GROUP ENG	MODEL 2017MY Forte (YDm) 2.0L MPI
	NUMBER 176	DATE September 2017
TECHNICAL SERVICE BULLETIN		
SUBJECT: SERVICE ACTION: ELECTRIC THERMOSTAT REPLACEMENT (SA308)

This bulletin provides the procedure to replace the electric thermostat on 2017MY Forte (YDm) 2.0L MPI vehicles, produced from May 23, 2016 through March 15, 2017, which may exhibit a Malfunction Indicator Lamp (MIL) ON with DTC P0128. This may be due to engine coolant intrusion through the thermostat Teflon® seal resulting in abnormal operation of the thermostat. To correct this concern, replace the thermostat assembly. Before conducting the procedure, verify that the vehicle is included in the list of affected VINs.

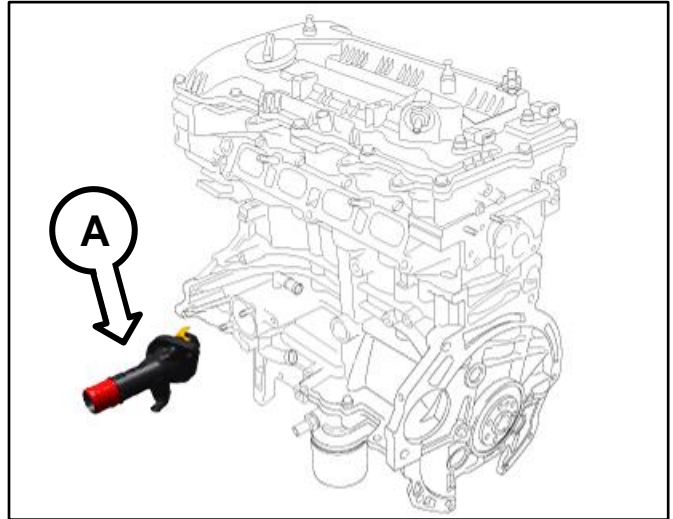
1. Replace the electric thermostat (A) by referring to the “Engine Mechanical System → Cooling System → Electric Thermostat → Repair procedures” chapter in the applicable Shop Manual on KGIS.

Tightening torque for thermostat:
 13.7 – 17.4 lb.ft (18.6 – 23.5 N.m,
 1.9 – 2.4 kgf.m)

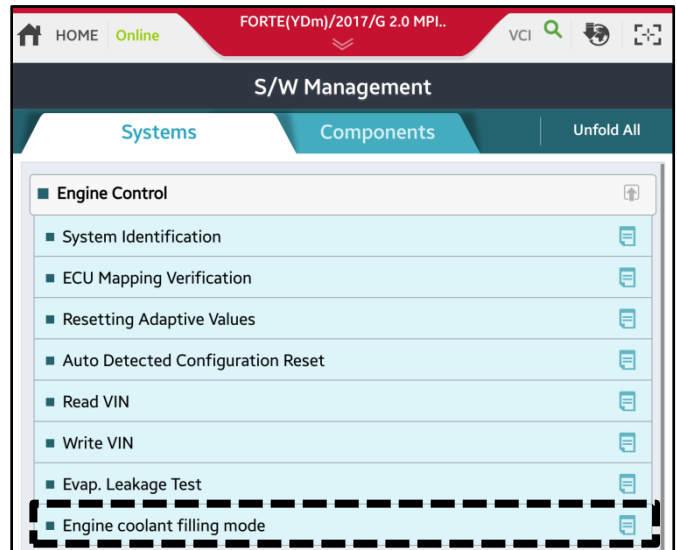
2. Be sure to properly fill and bleed the coolant system using the KDS → Engine Coolant Filling Mode, as shown, and by referring to the “Engine Mechanical System → Cooling System → Coolant → Repair procedures” chapter in the applicable Shop Manual on KGIS.

Fill the coolant system with the recovered coolant. If needed for top-off, add 50/50 coolant or mixture appropriate for area.
